TECHNICAL SERVICE BULLETIN

TSB#: 16-012

Entegra Coach has determined that certain Model Year 2016 Cornerstone 45A and Anthem 44A Class A Motorhomes require an update to the living room slide track to ensure proper closure of the slide.

3 Fig 5: Push the plates all the way toward the front of the slideout so they are seated against the metal lip.
(Photo taken before slideout was installed)

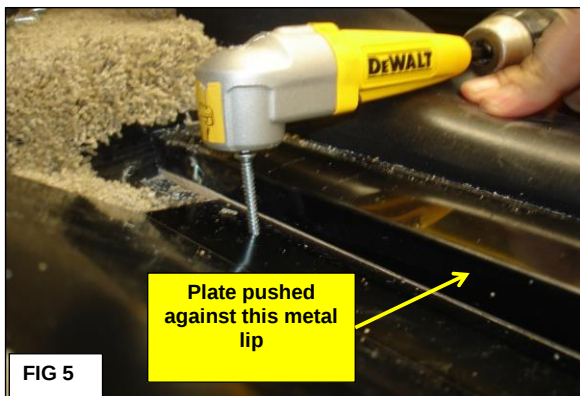
Plate location must be centered on the roller to avoid contact with the two screws.

5 Print shows the location of all four plates and dimensions for each location (plates are shown in yellow).

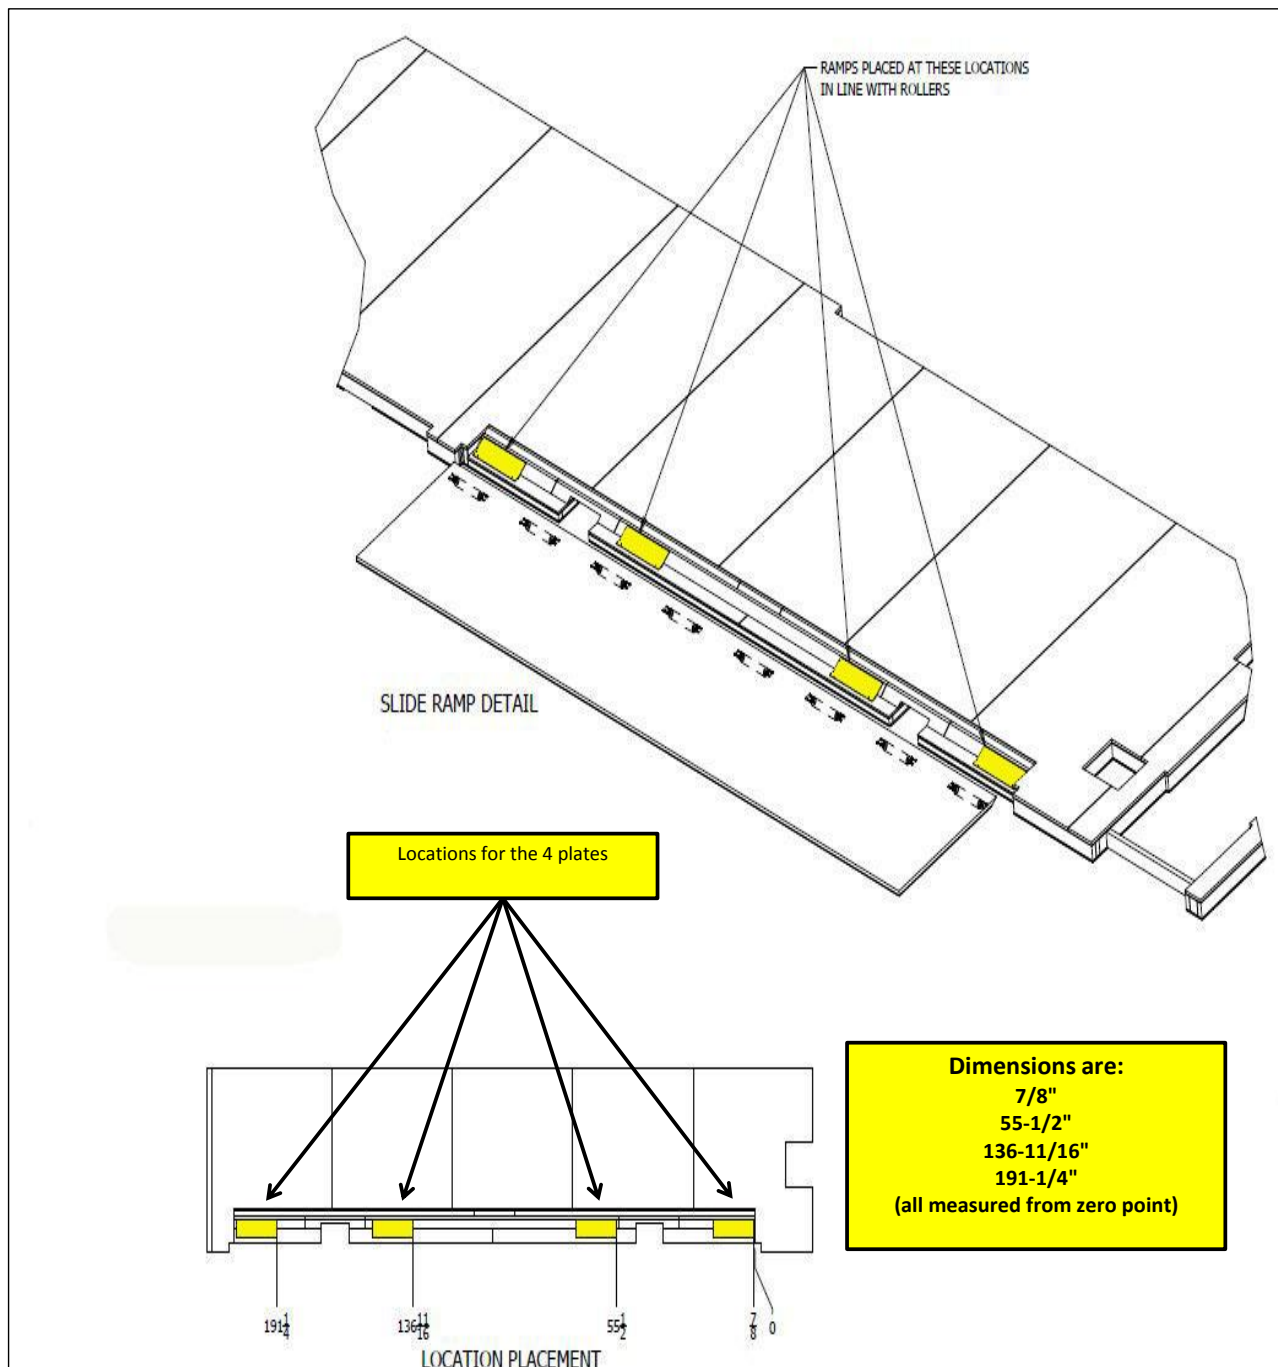
Install 4 steel plates, centered with 4 of the 9 rollers on the slideout.
Locate 1 plate at each end of the slideout centered on the end rollers (total of 2 plates)
Locate 2 plates at the center of the slideout - centered on the 2 middle rollers.
Refer to the print with instructions for the location of all four plates on the slideout.
